EARLY DESIGN GUIDANCE OF THE NORTHWEST DESIGN REVIEW BOARD

Project Number: 3012980

Address: 2014 NW 57th Street

Date of Meeting: Monday, February 27, 2012

Concept C - Preferred Scheme

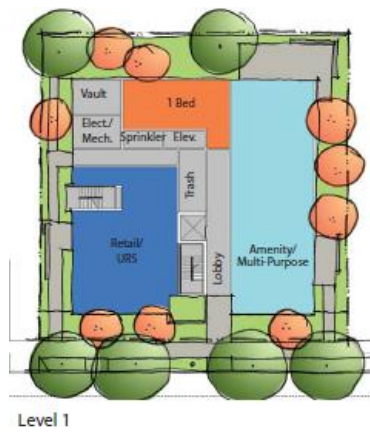
1. Reduce the front setback to hold the street edge to develop a more urban condition. The area gained by encroaching into the front yard should be reflected with greater upper level setbacks. Suggested stepping back the after the first or second stories to reduce the scale and better relate to the pedestrian environment. Request departure if necessary. (A-2, B-1, C-3)
2. Suggested flipping the floor plan to soften impacts to the north and east. (B-1)

12. The Board was pleased with the early direction of the architectural concept. (C-2)
13. The Board looks forward to reviewing detailed color and material board. (C-4)
14. Include an overhead canopy at the front entry. (C-3, D-1)
